December 6, 2012

**Aquinas High School Addition
3420 Main Road
David City, NE**

ADDENDUM NO. 2-1

Ref. Sheet #: A112F
Date: 12/6/2012

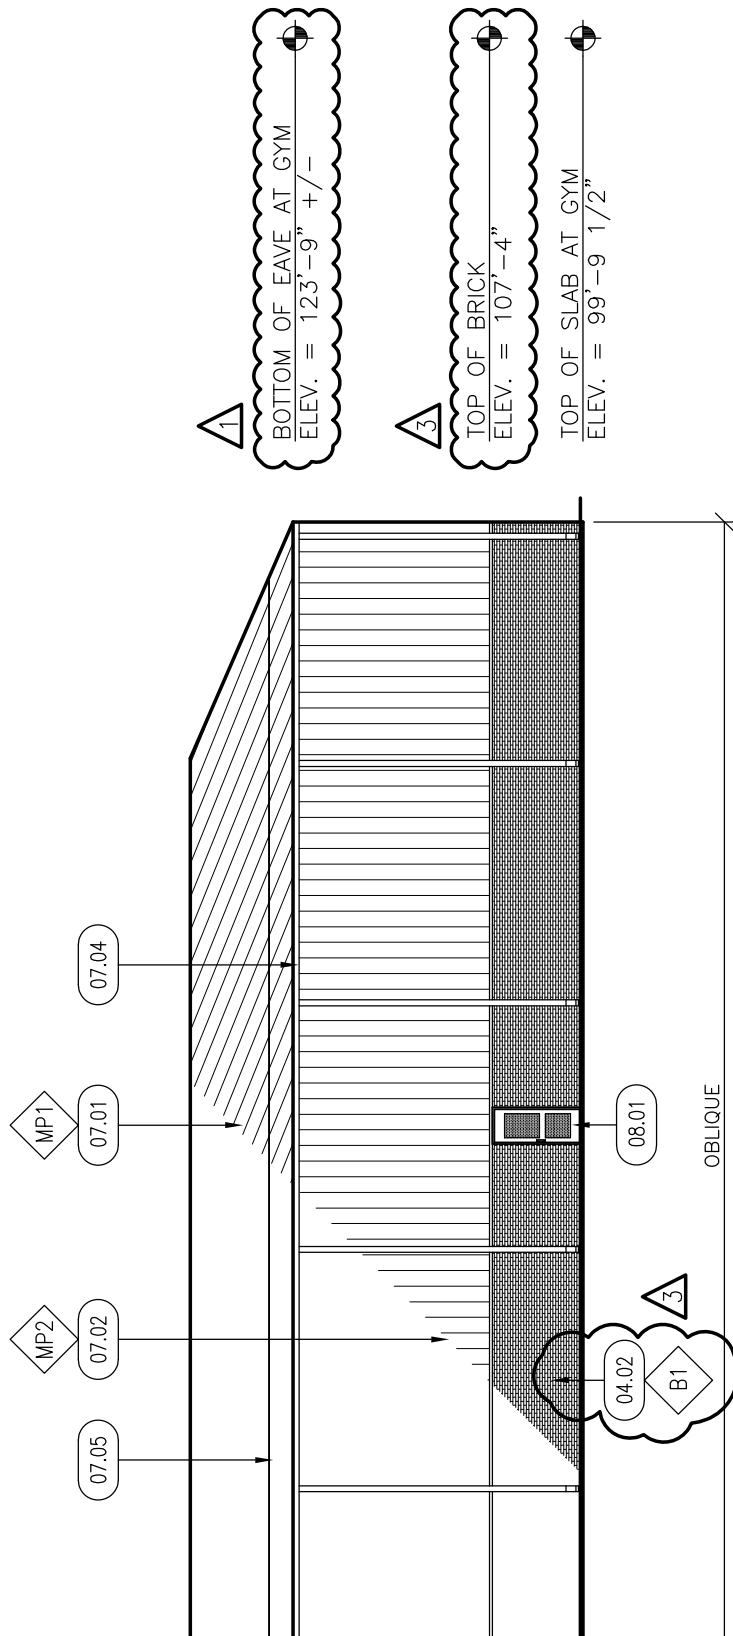
2. Sheet A112F, Detail A1, Main Level Floor Plan – Area F:
 - A. At west exterior wall and north exterior wall (west entrance of Gym 160), delete exterior metal panel from grade to 7’-4” above finish floor. Add metal frame wall, batt insulation, exterior gyp and brick veneer from grade / finish floor to 7’-4” above finish floor. See Attachment 2.

Addendum 2-1
Attachment 3

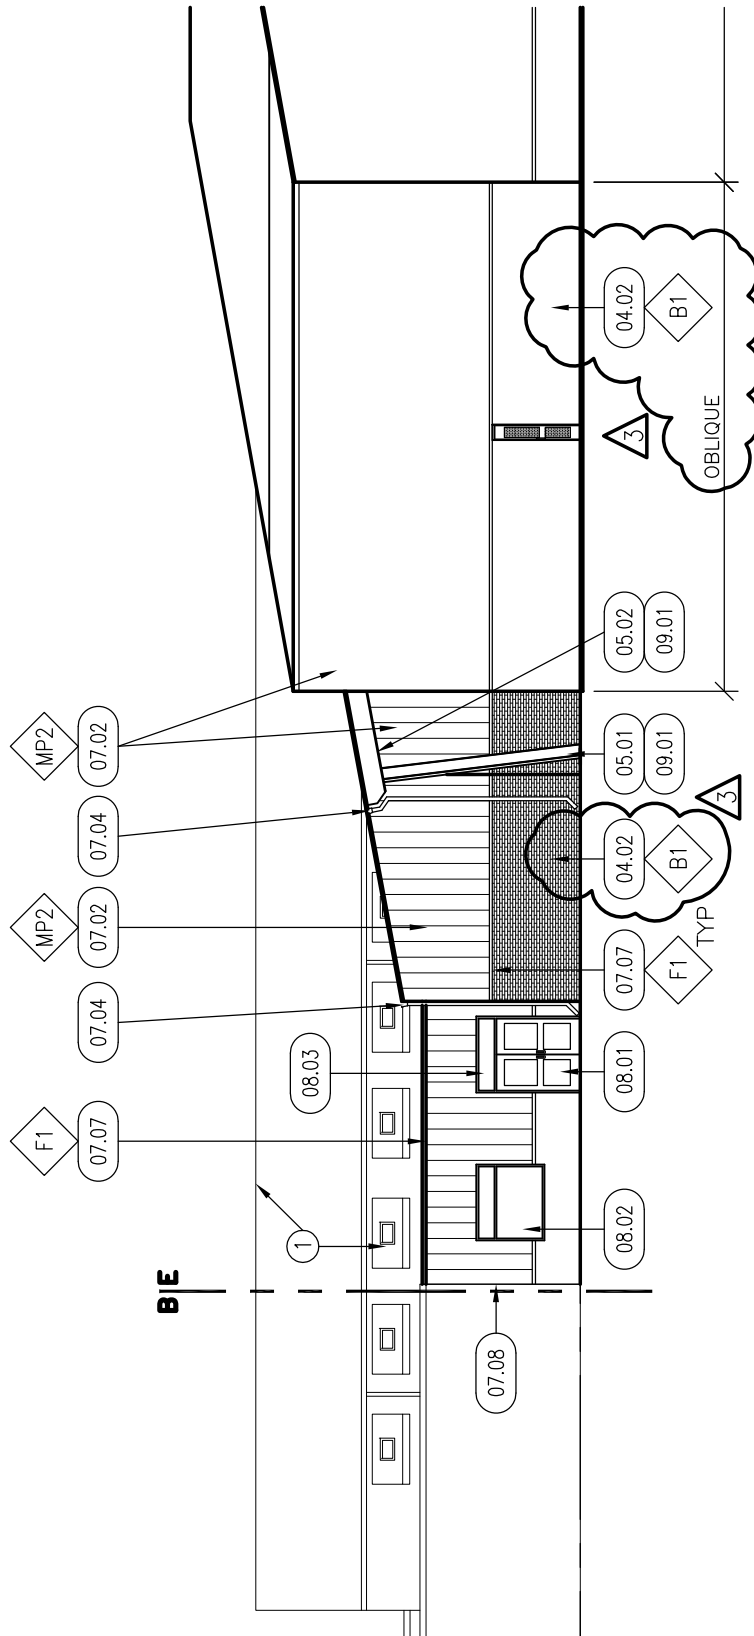
4. Sheet A400, Exterior Elevations:
 - A. Detail O1:
 - a. Revise detail title from “East Elevation...” to “West Elevation...”
 - b. At Gym Elevation - Delete exterior metal panel from grade to 7’-4” above finish floor. Add brick veneer from grade to 7’-4” above finish floor. See Attachment 3.

J12	SECT AT NEW GYM EXT WEST WALL
A502	SCALE: 3/8"=1'-0"

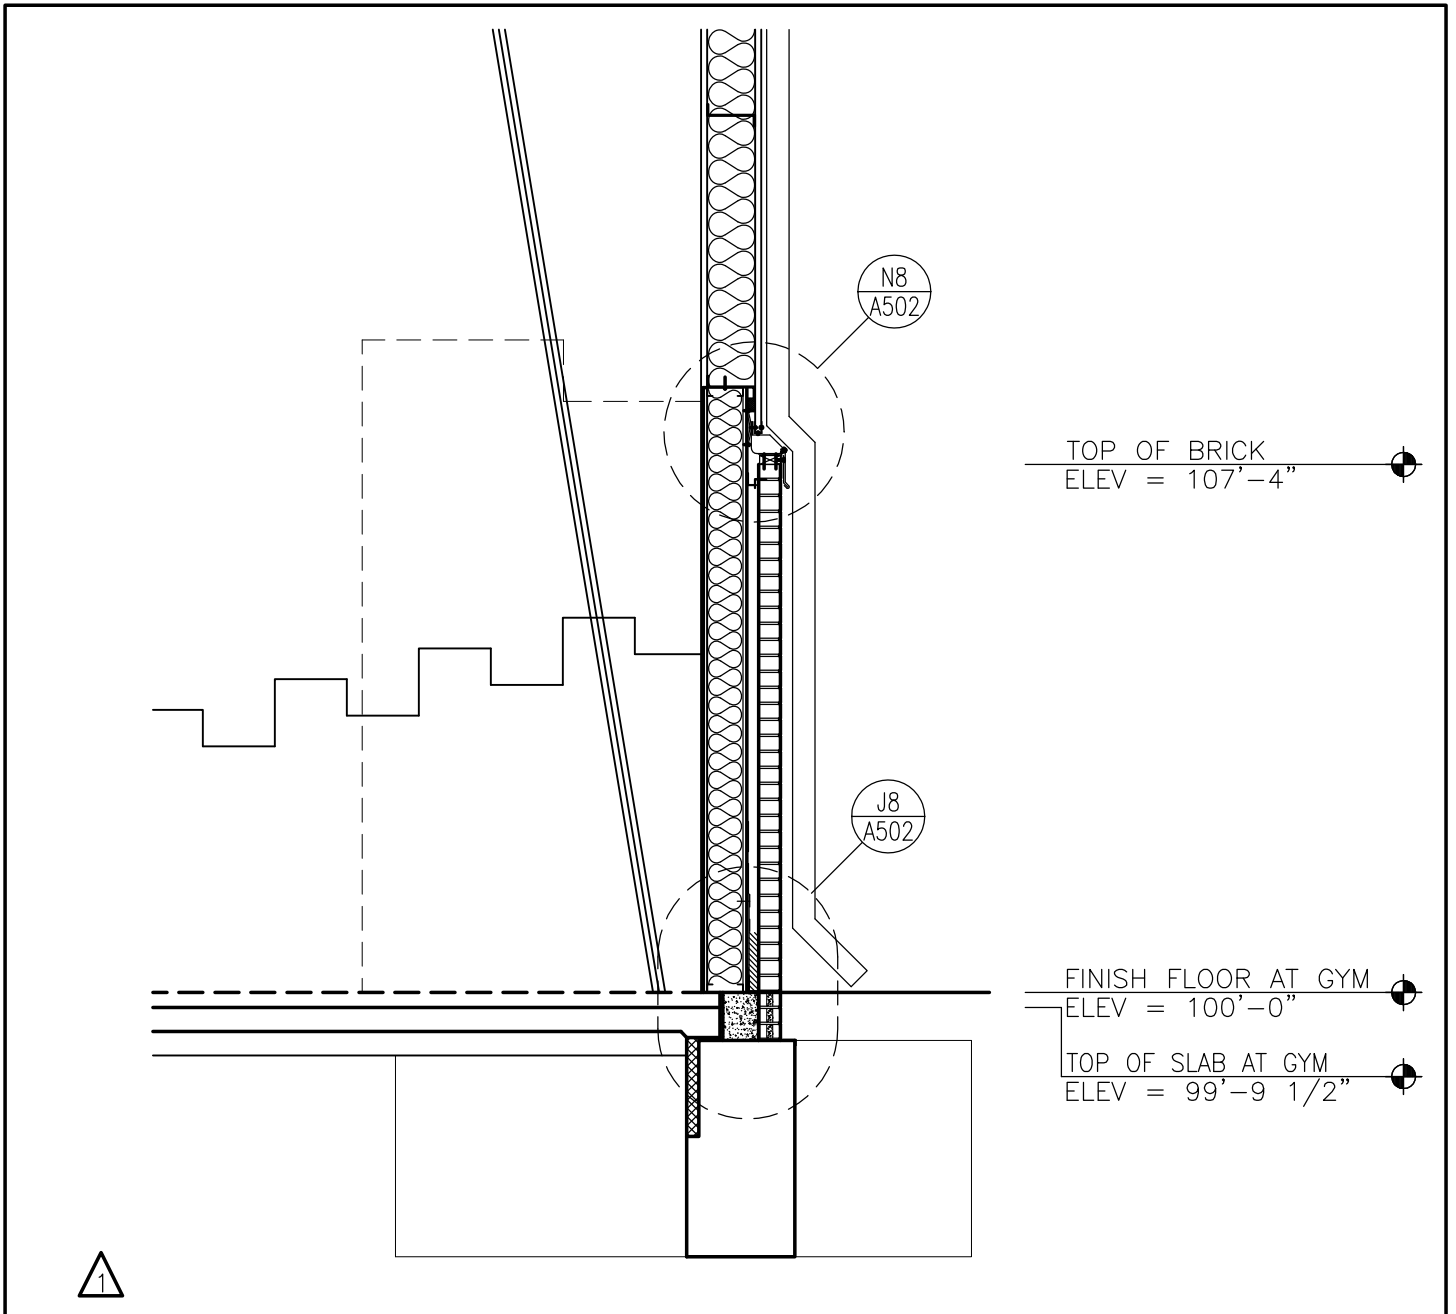
5. Sheet A502, Wall Sections and Details:
 - A. Add Details J12, N8, J8 (Attachments 5, 6 and 7) Wall section at masonry veneer.
 - B. Add Key Notes (Attachment 8).

L1	EAST EXTERIOR SOFFIT DETAIL
A503	SCALE: 3/4"=1'-0"

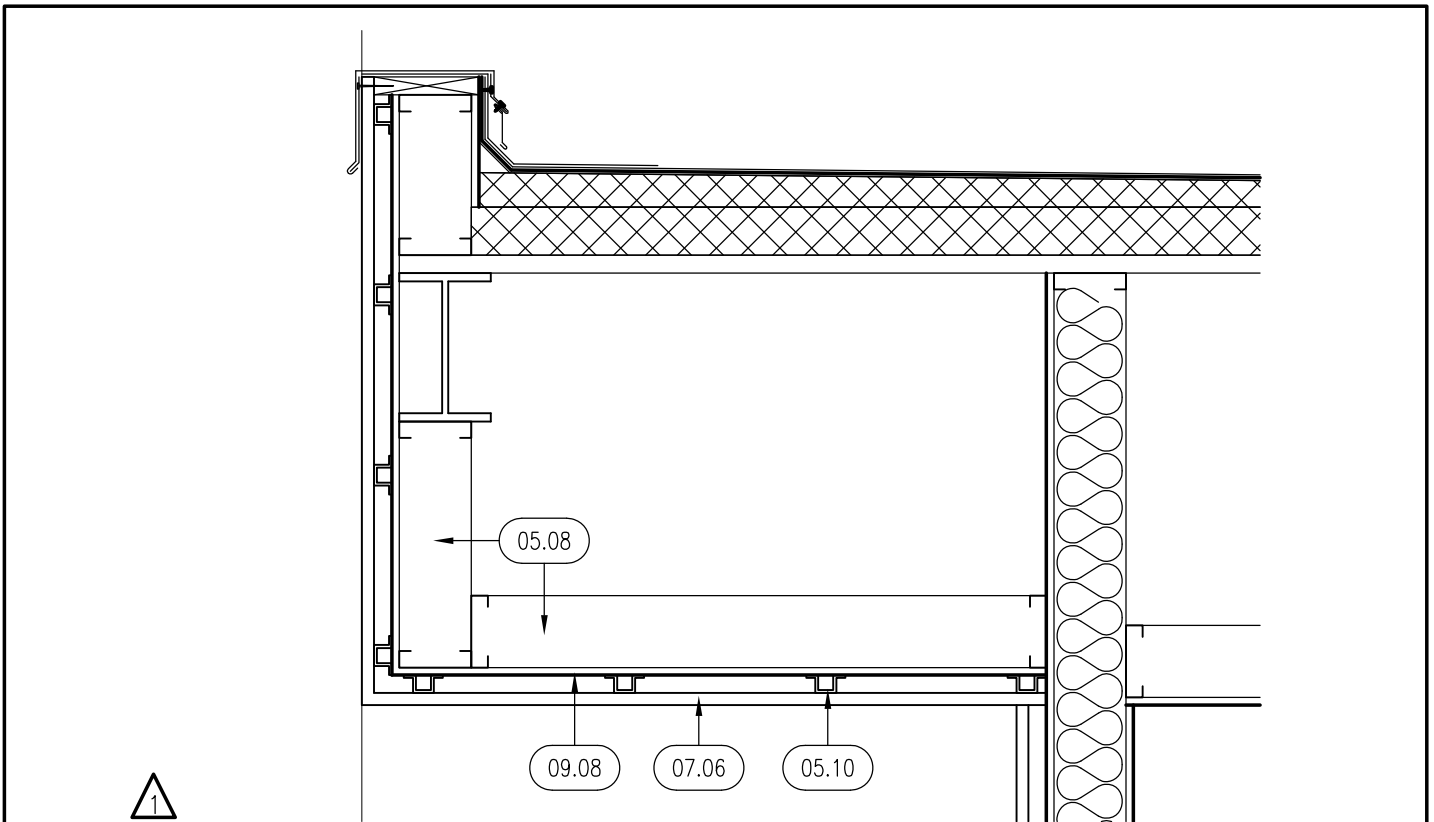
6. Sheet A503, Detail G16, Wall Sections and Details:
 - A. Add framing, exterior gypsum board and framing channels at exterior fascia and soffit. See Attachment 9.

G4	12 7/8" EXT. BRICK WALL
A700	SCALE: 1 1/2"=1'-0"

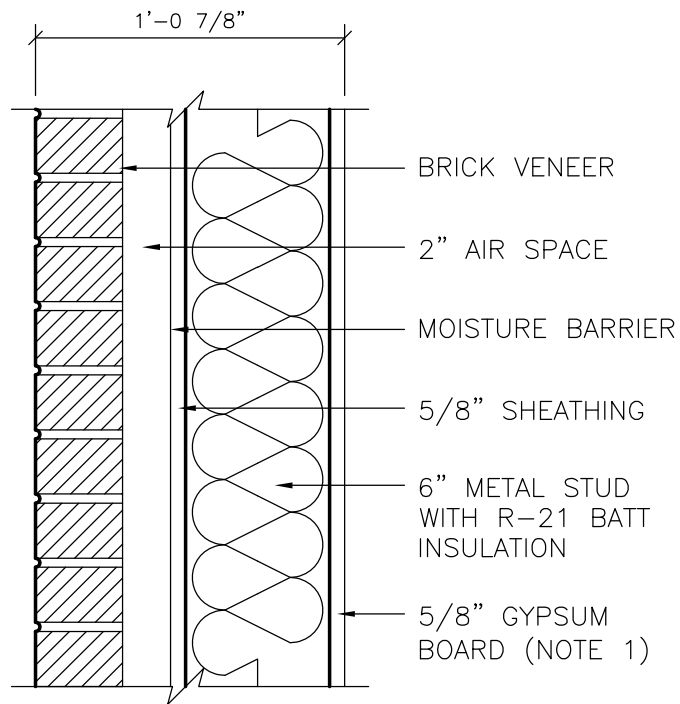
7. Sheet A700, Wall Type Details:
 - A. Add Detail G4 (Attachment 10) Wall type at masonry veneer.
